BEN LOMAND MOUNTIAN VILLAGE

PRELIMINARY PLAT

BEN LOMAND MOUNTAIN VILLAGE

PRELIMINARY PLAT

PROJ. MGR.: DJM
PROJ. ASSOC.: BB
DRAWN BY: ---
DATE: 03/06/2026
SHEET
12 OF 23
UNCMOC001

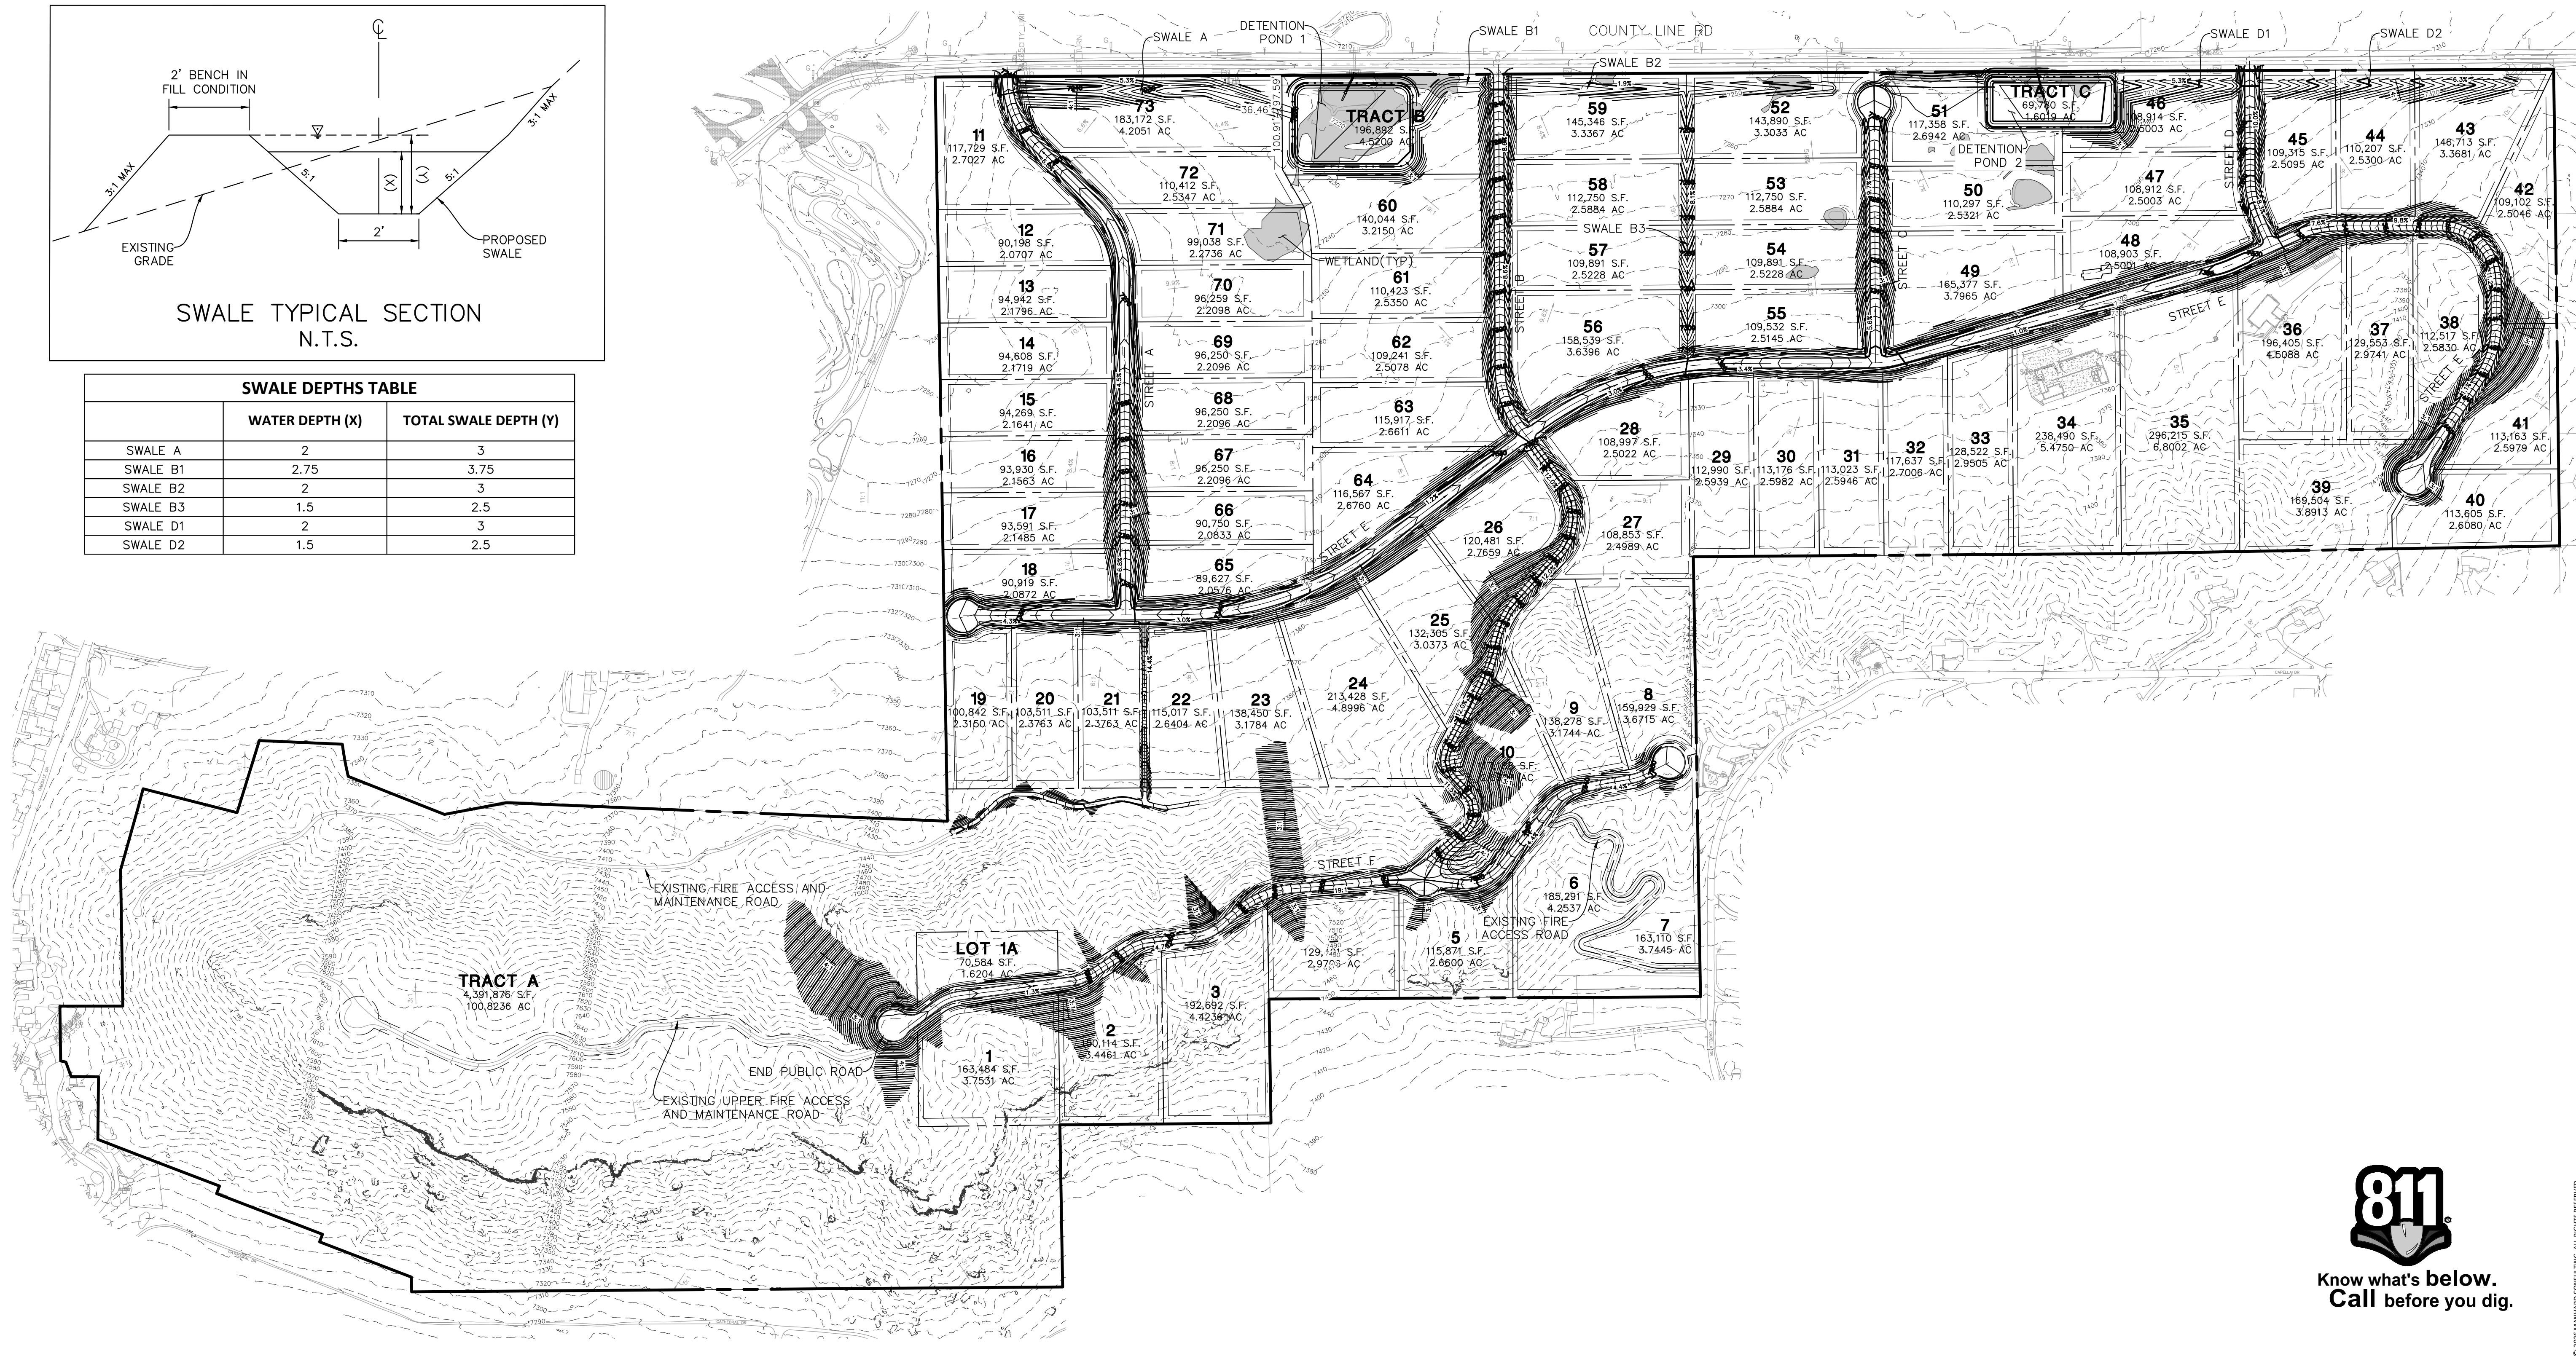
GRADE WITHIN UTILITY EASEMENTS MAY NOT EXCEED 15% SIDE SLOPE
RETAINING WALL AND ITS COMPONENTS MAY NOT ENCROACH INTO
UTILITY EASEMENTS

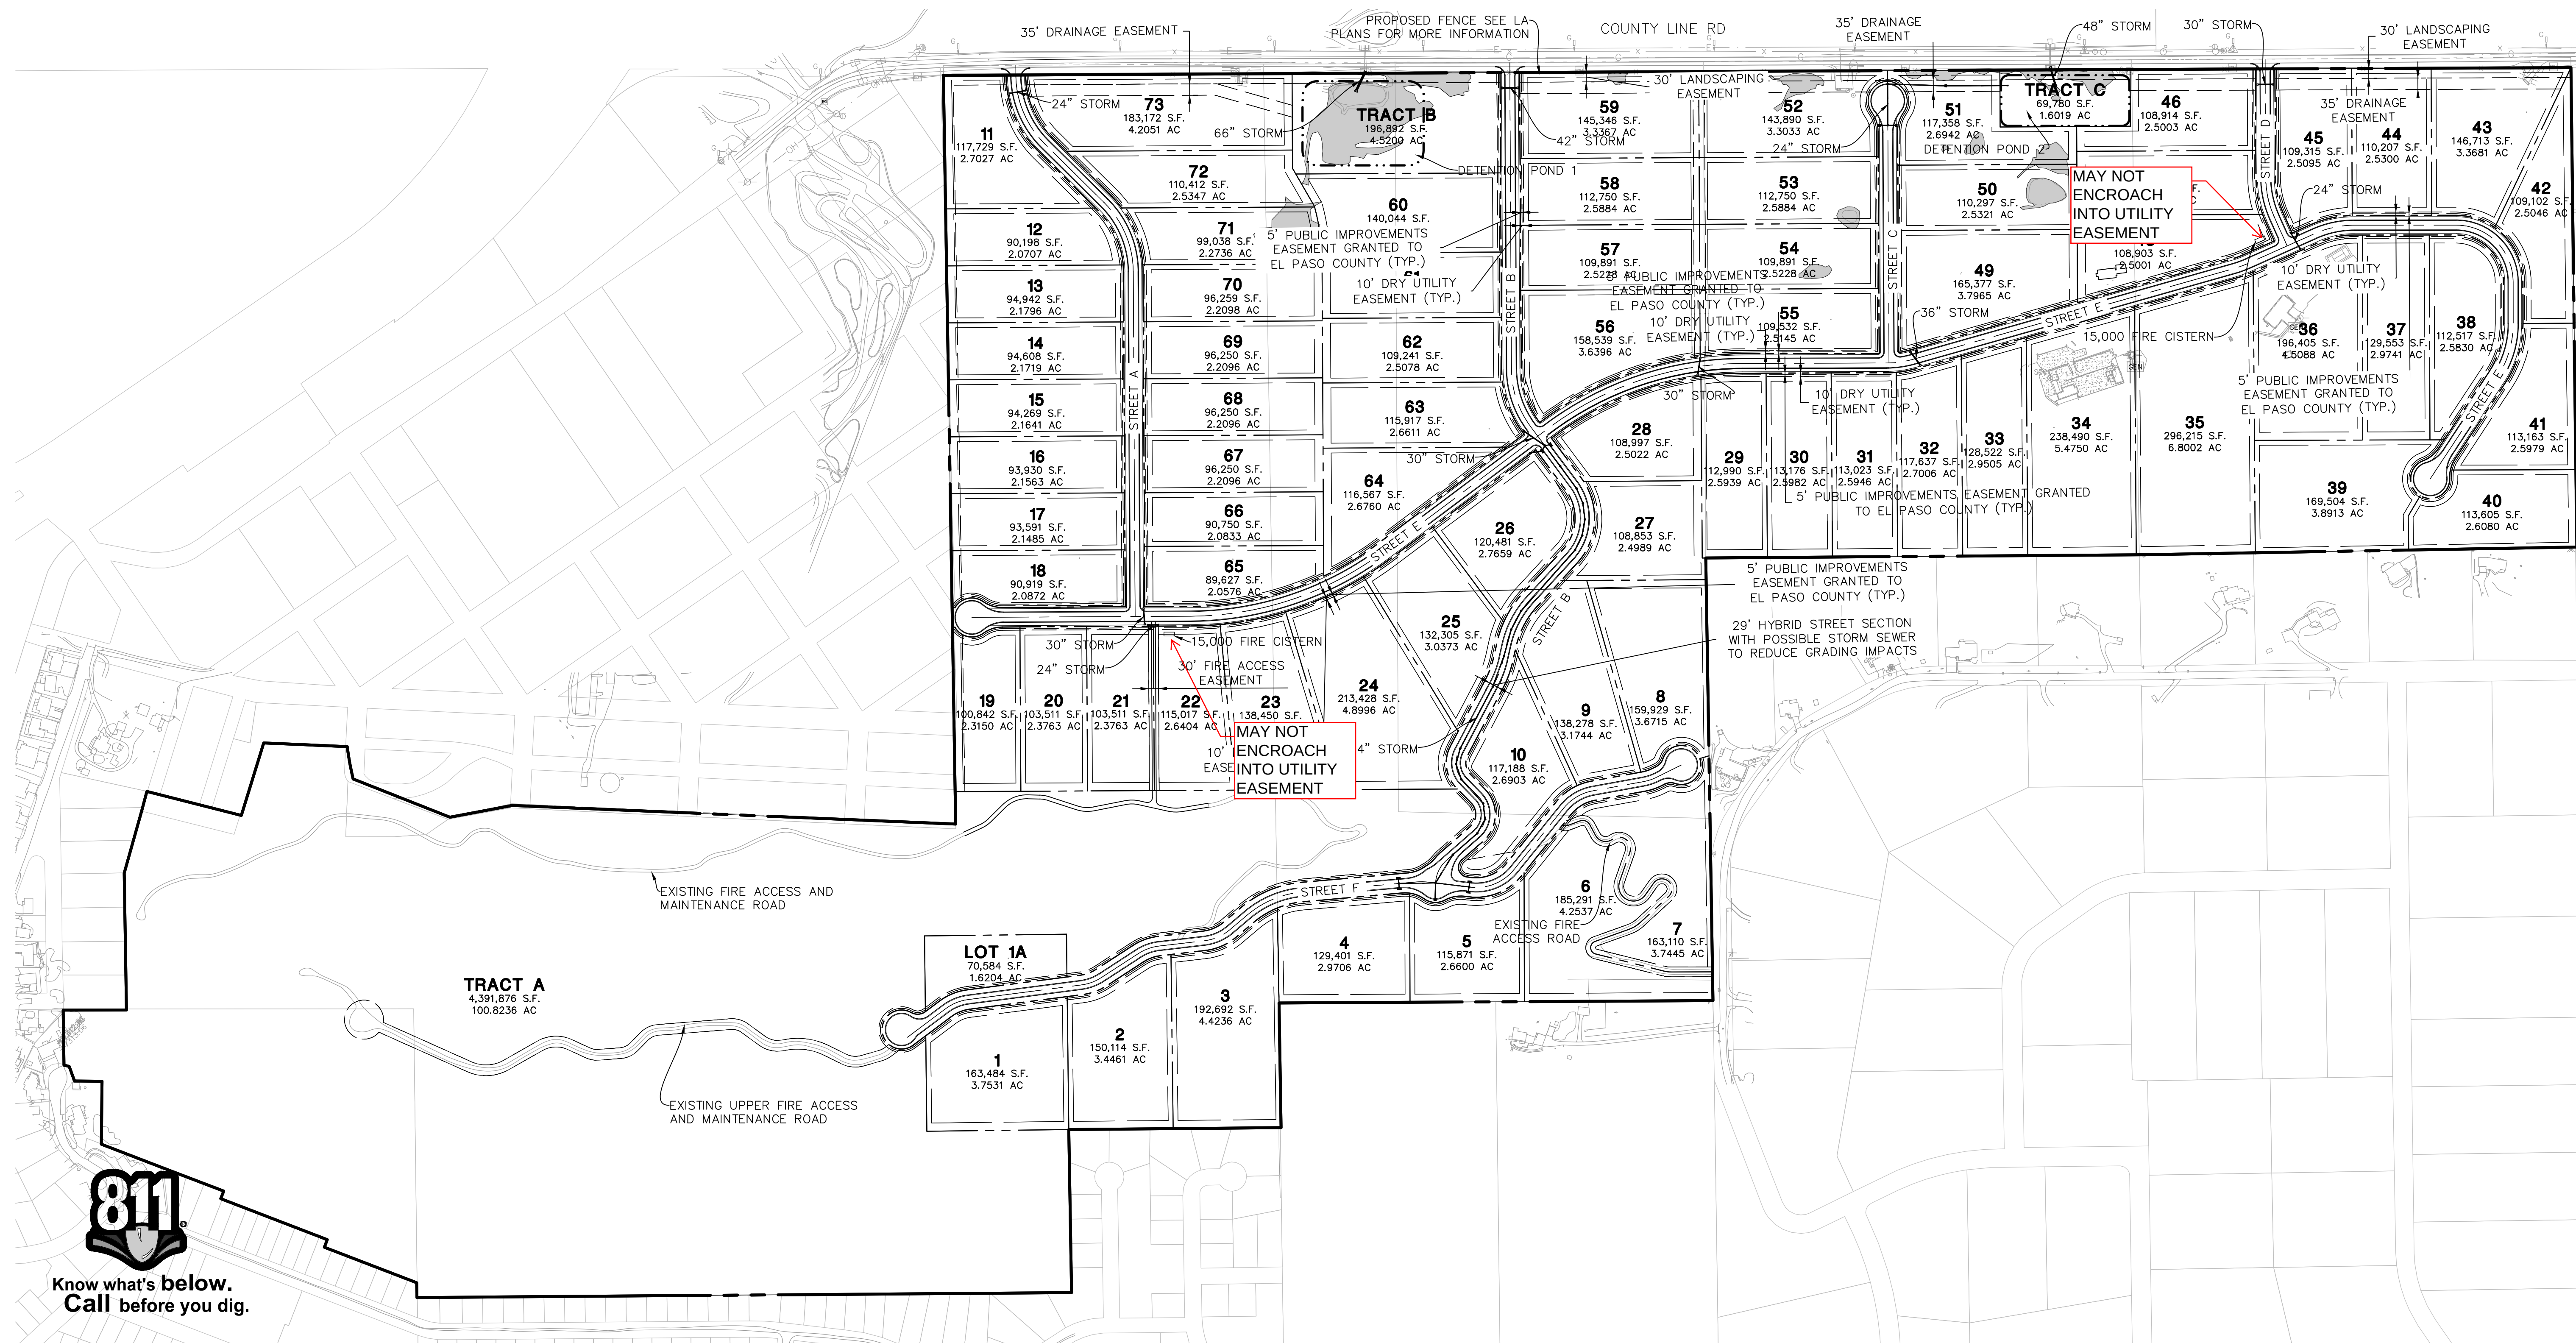
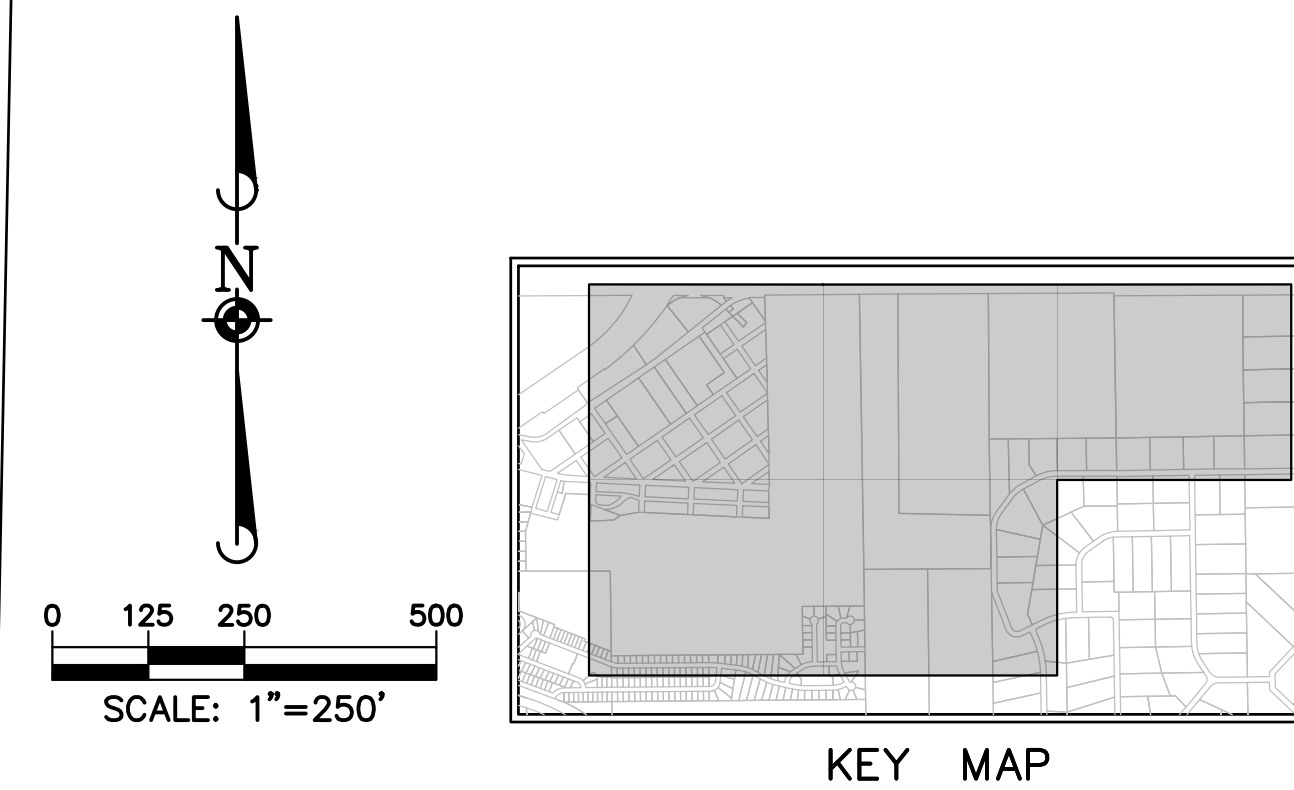
GRADE WITHIN UTILITY EASEMENTS MAY NOT EXCEED 15% SIDE SLOPE
RETAINING WALL AND ITS COMPONENTS MAY NOT ENCROACH INTO
UTILITY EASEMENTS
